ALLEGHENY COUNTY SANITARY AUTHORITY

CONTRACT NO. 1729 G, E, H, P

EAST HEADWORKS

ADDENDUM NO. 10

**530-A-15
EAST HEADWORKS
ROOF PARTIAL PLAN - C**

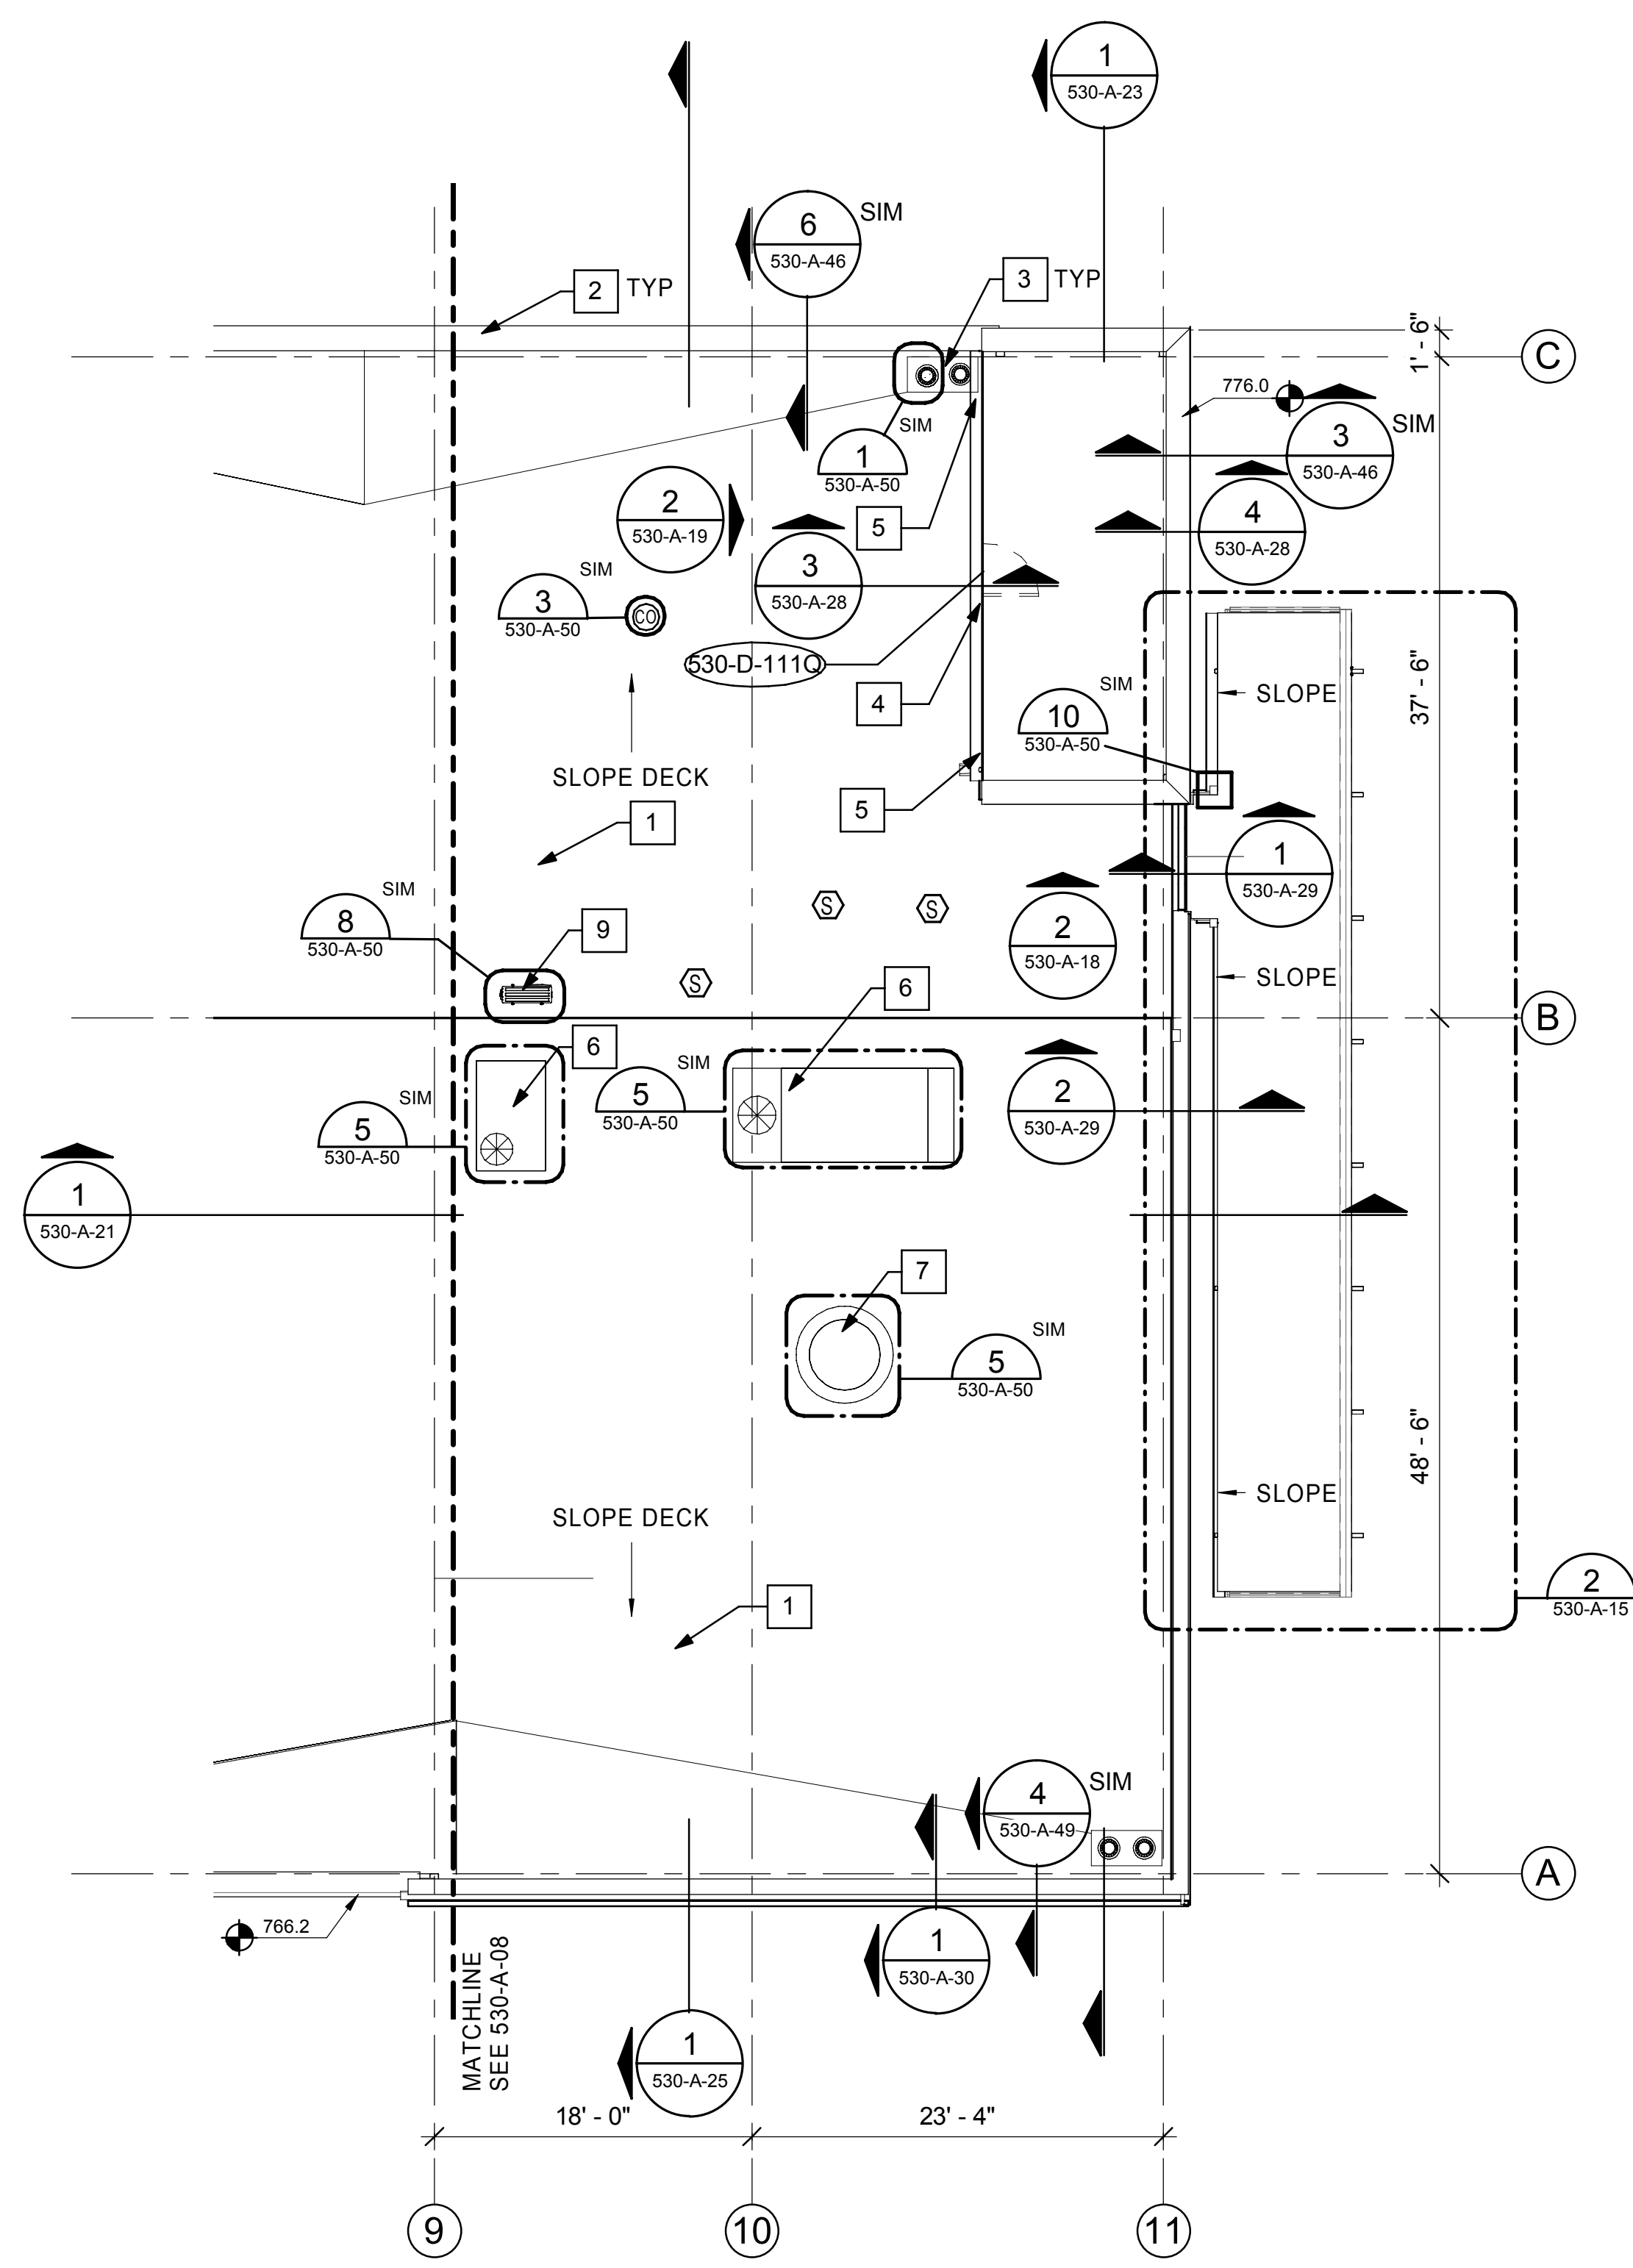
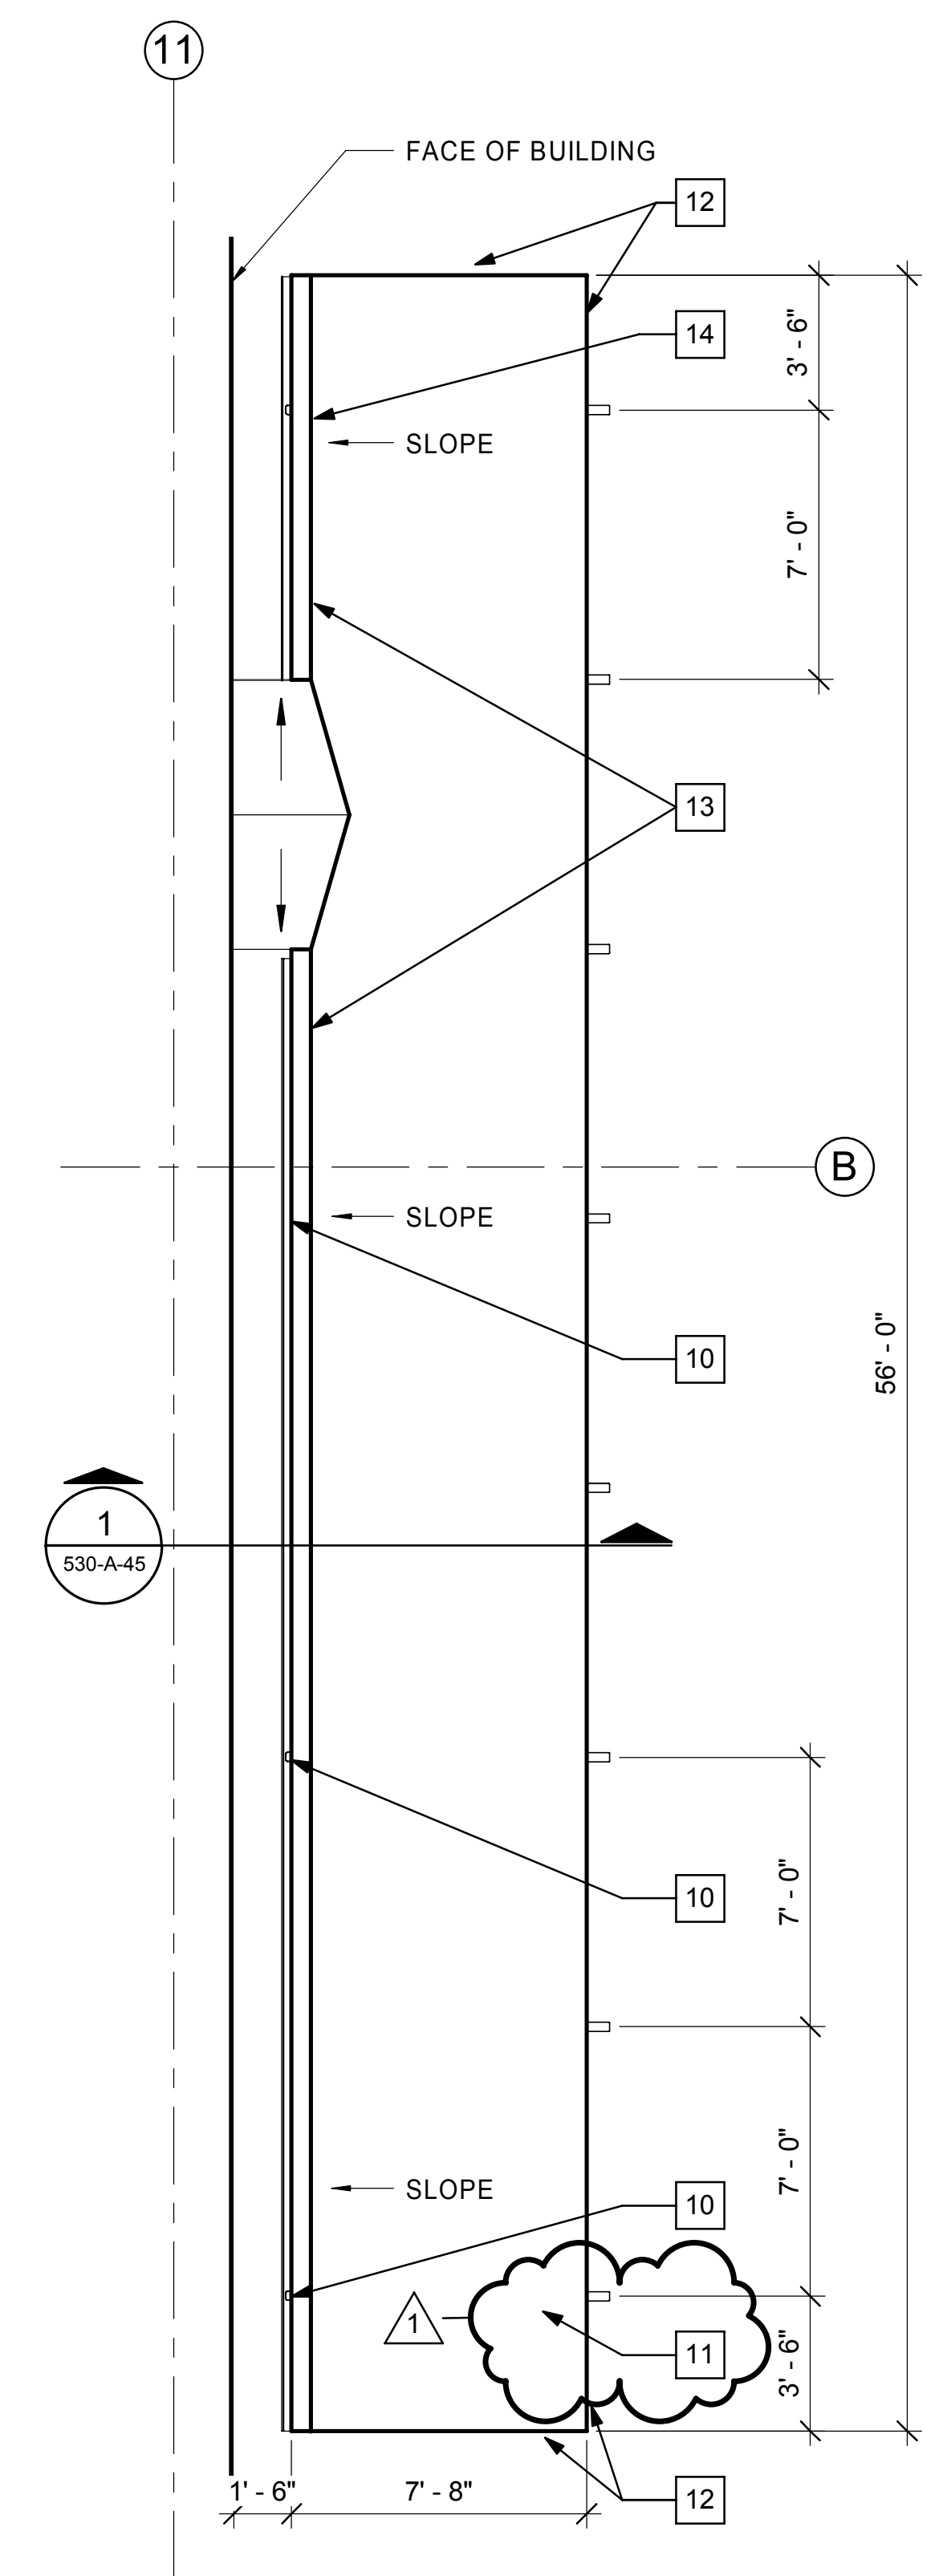
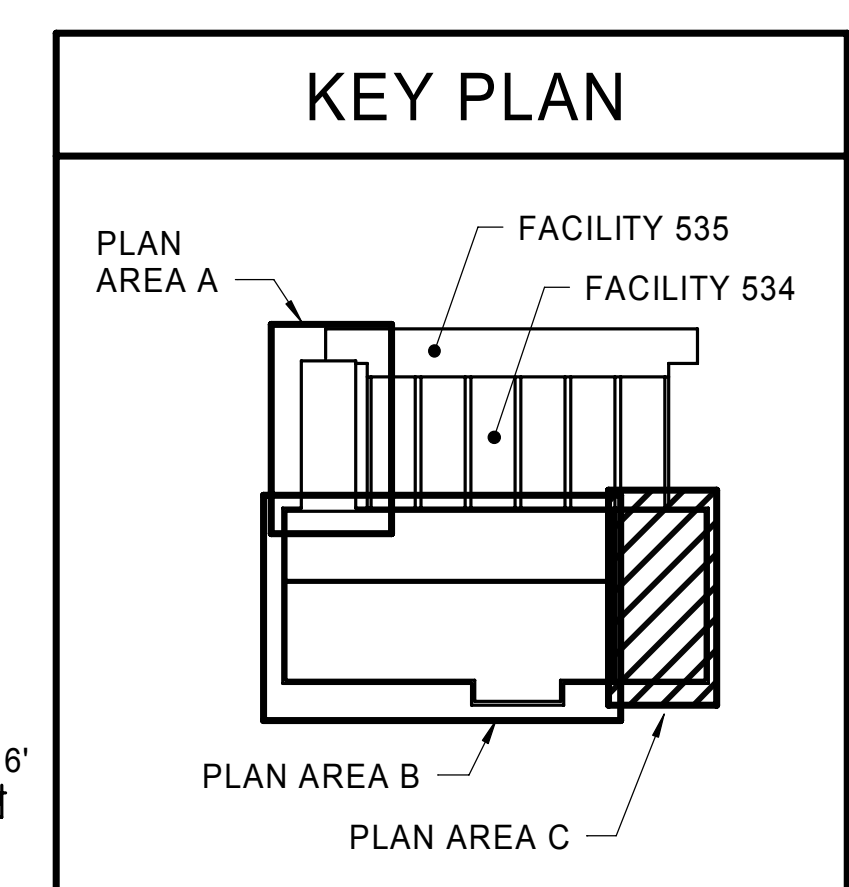
222. **QUESTION:** Please confirm what type of roofing the canopy is. Reference sheet 530-A-45.

RESPONSE: All roofs are Modified Bitumen as specified in Section 07 52 16. Sheet 530-A-15 has been updated and included with this addendum.

D INTERIOR PARTITION TYPE

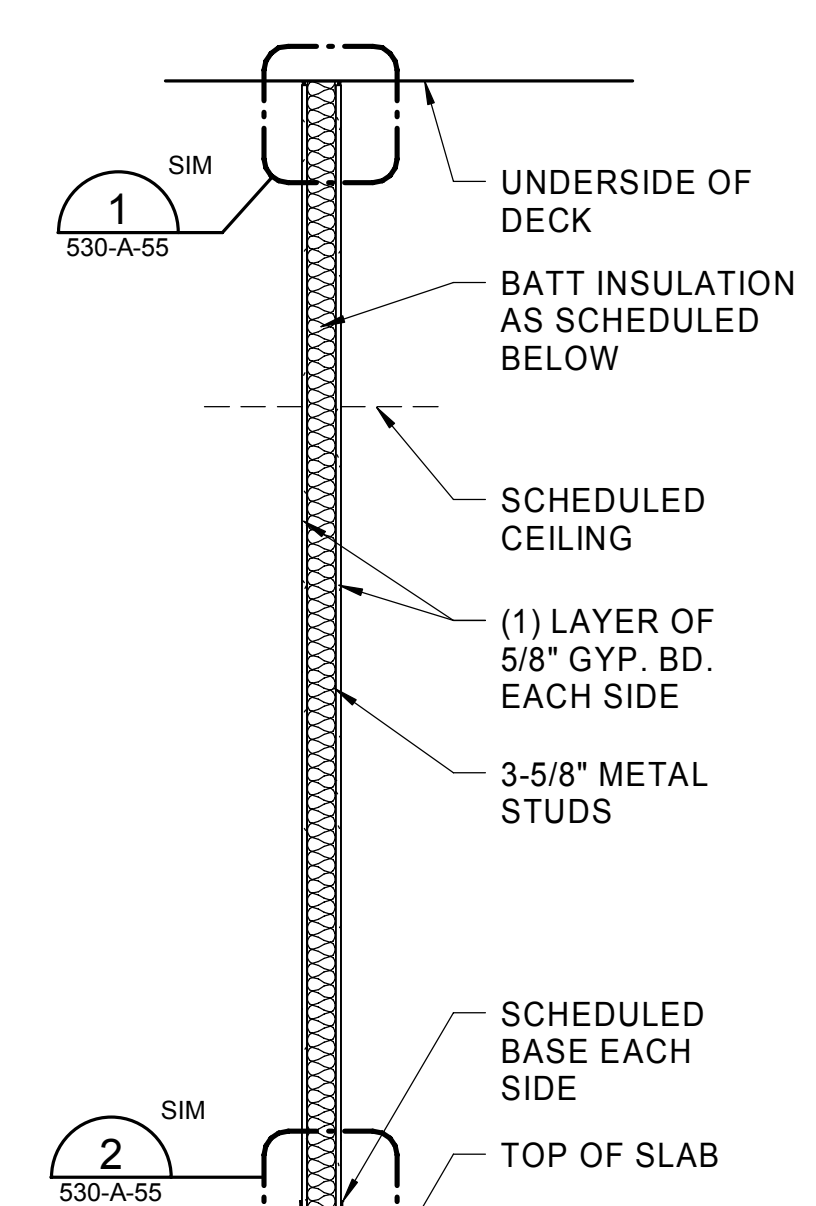
223. **QUESTION:** Sheet 530-A-11 shows a partitions labeled 0D.1. It appears to be a fire rated vertical panel. However, there is no partition type for this. Please confirm.

RESPONSE: This partition is not required to be rated per code. However, it is required to be airtight. The D Partition Type on sheet 530-A-55 has been updated and included with this addendum.
